ISSUE: Certificate of Appropriateness for alterations

APPLICANT: Landini Restaurant, Inc. Noe Landini

LOCATION: Old and Historic Alexandria District
115 King Street

BAR APPLICATION EXTERIOR DUCTWORK V2
May 10, 2023

Figure 3: Comparison of previous proposal (left) and current proposal (right)

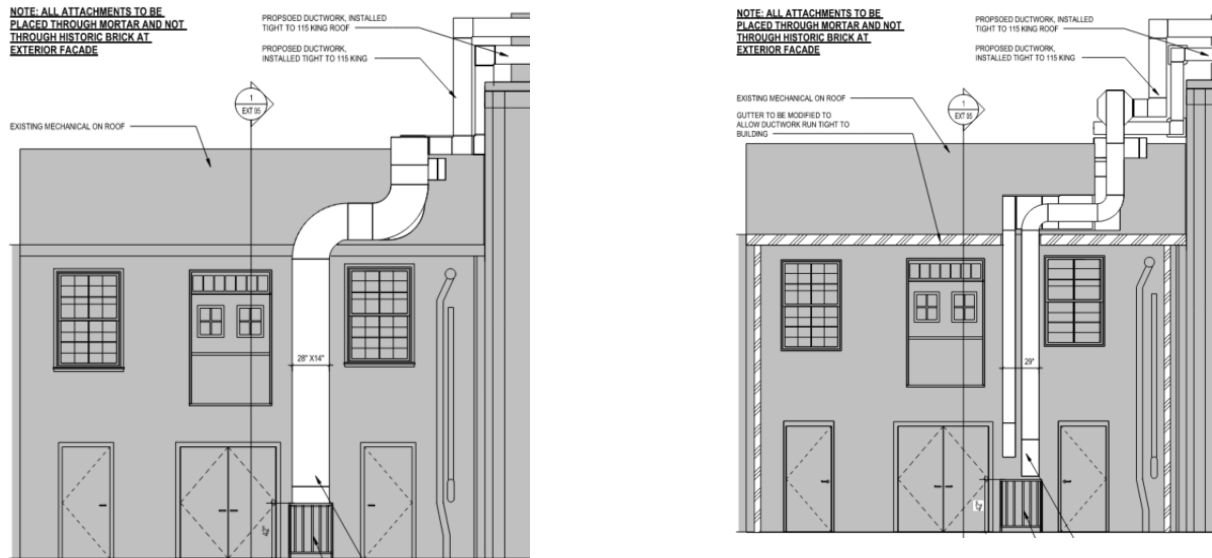
At the previous BAR hearing, Board members commented on the extent to which the proposed ductwork protrudes into the alley. The suggestion was made that the ductwork be reconfigured so that the ducts are side by side instead of stacked and that the existing gutter be reconfigured to bring the new ducts as close to the exterior wall as possible (Figure 3). In response to these comments, the applicant has reorganized the path of ductwork and reconfigured the roof drainage.

The intent of this reconfiguration is to limit the distance that the ductwork protrudes from the wall to reduce the overall impact of the ductwork on the blockface. As the applicant has continued to study options for the ductwork they took another look at the 3-D laser scan of the existing building and have determined that the first floor door and second floor window on the west end of the elevation is actually closer to the center door and window than previously drawn. Along with the required proportions for the ductwork, the result is that in this new configuration, the duct will protrude approximately the same distance from the exterior wall as in the previous scheme (Figure 4). Note that in the current submission, the applicant is providing for a reconfiguration of the gutter and a new downspout to bring the ducts as close to the wall as possible.

Staff recommends approval of the Certificate of Appropriateness for alterations with the previously proposed option with the ducts stacked, as depicted in Figure 3.

Staff appreciates the applicants efforts to explore options to locate the proposed ductwork at the building interior and to limit the impact on the exterior. Given that the location of the existing windows and doors limit the ability of the applicant to locate the ducts side by side with the long direction against the wall, staff finds that the previous proposal with a single duct facing the alley and another facing the building is the least visually obtrusive option. Staff appreciates that the applicant has selected an installation plan for the equipment that limits the damage to the existing structure to the greatest extent possible and carefully locates the wall penetration so as not to disturb existing openings. If the requirements for the structure change in the future, this work could easily be reversed. This alley is clearly a service alley for the restaurants facing King Street and the architectural context includes many elements similar to the proposed ductwork. This proposal will not change or detract from the architectural character of this alley. Staff finds that this is a unique location within the historic district and recommends that the Board of Architectural Review approve the requested Certificate of Appropriateness for the previously proposed option with the ducts stacked.

PROPOSED FIRST FLOOR PLAN REVISED

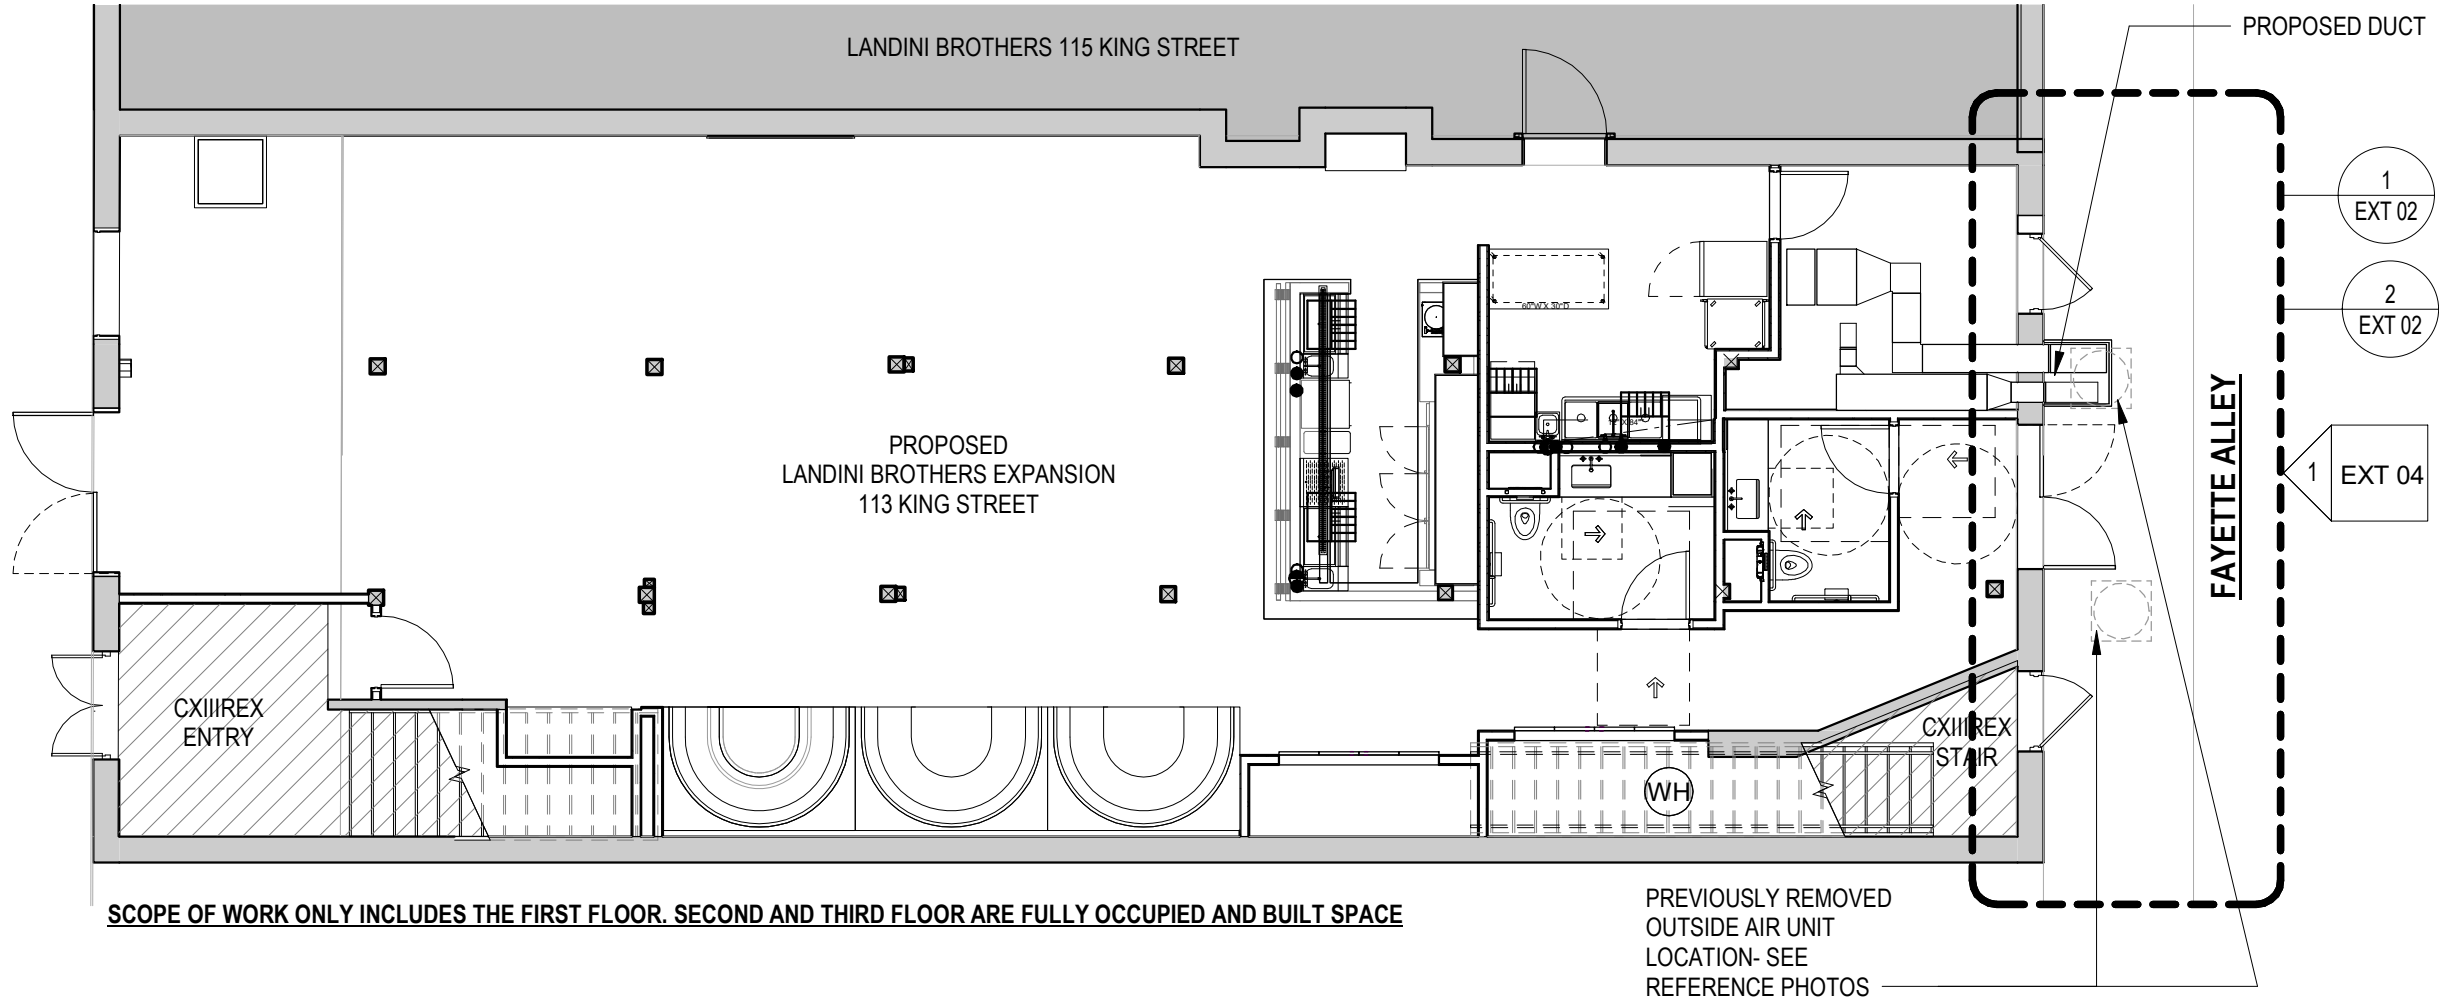
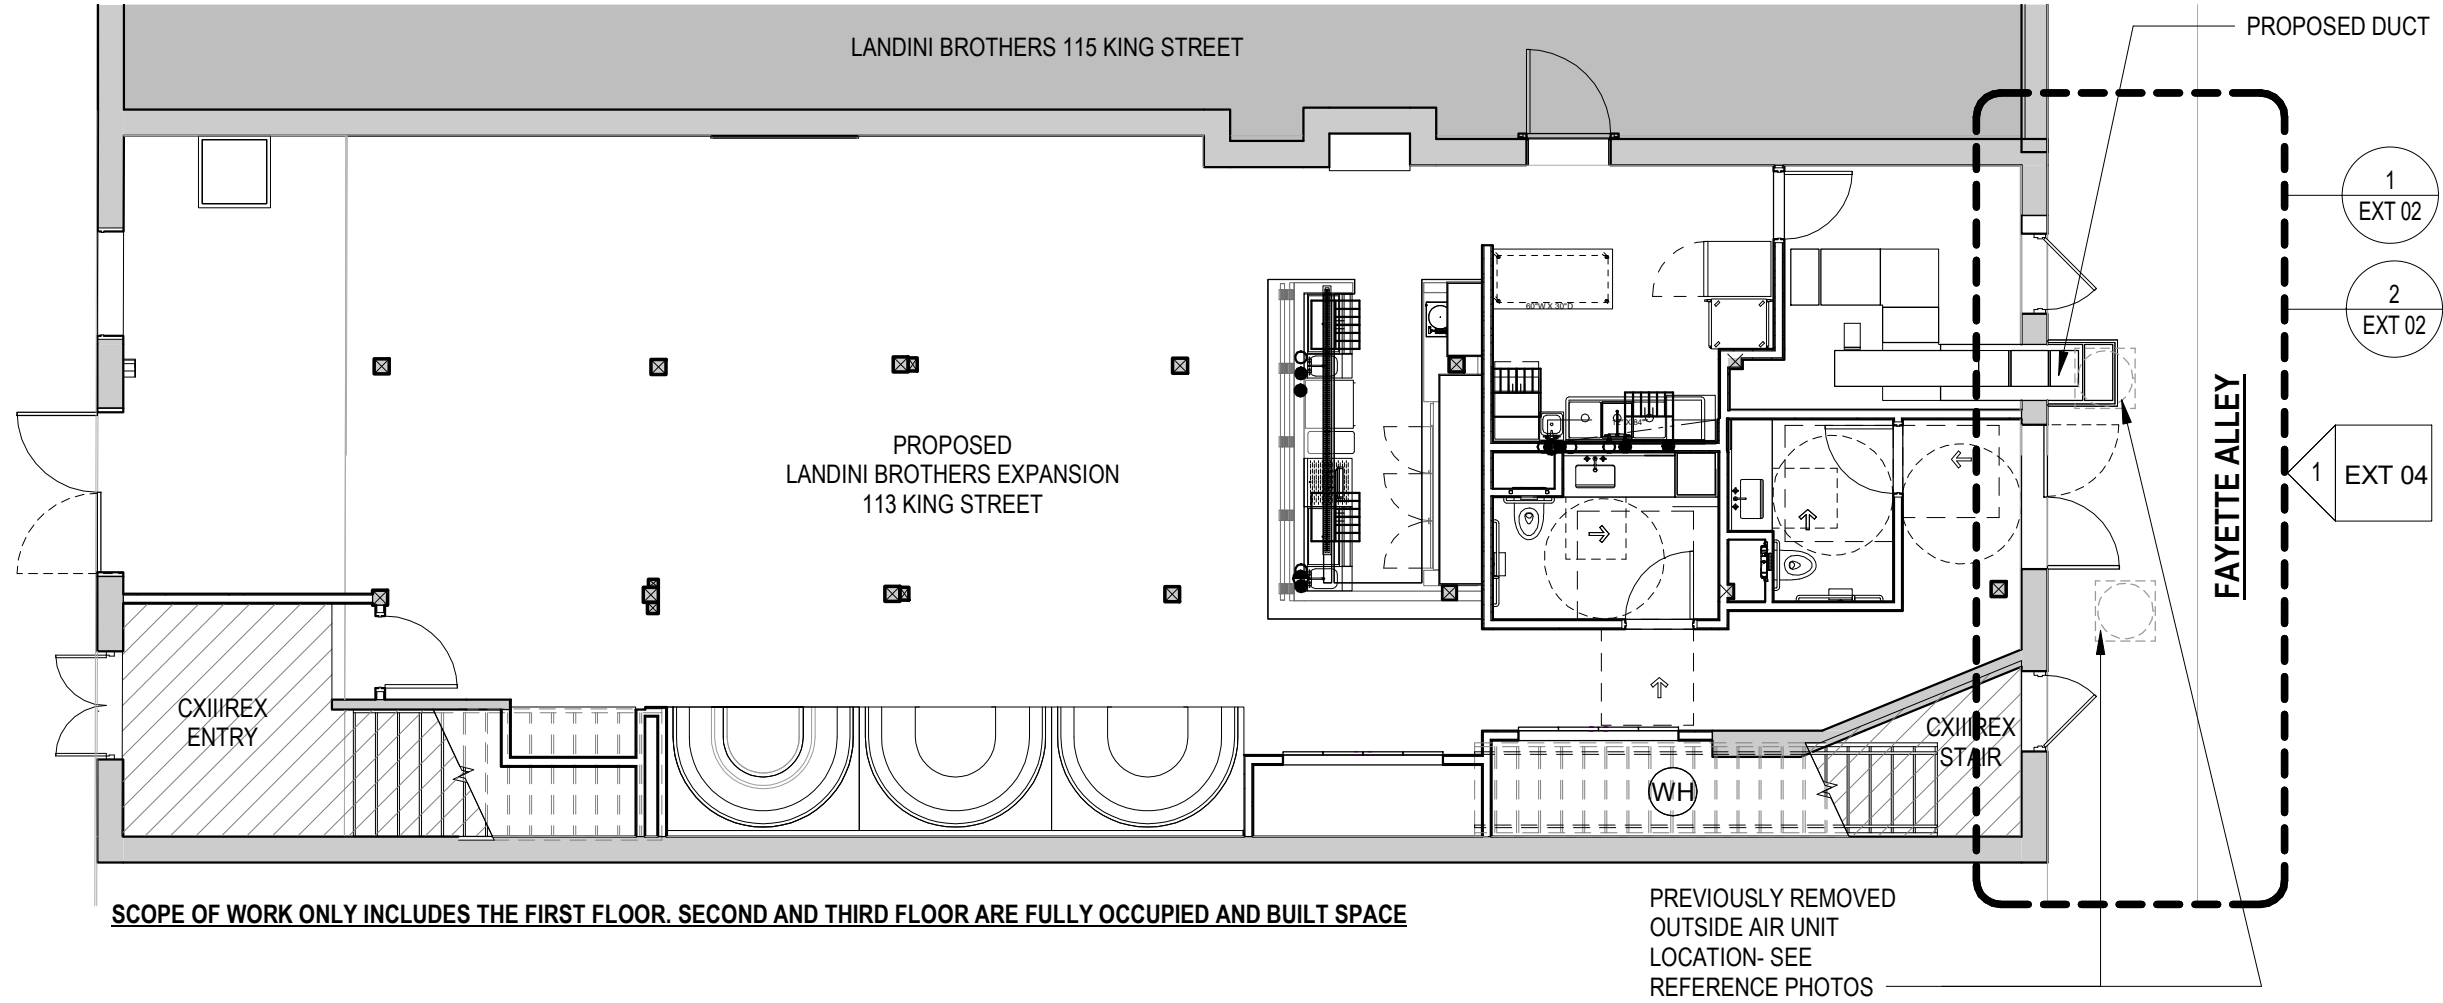
REVISED PER 5/4
HEARING COMMENTS

REQUESTED REVISIONS
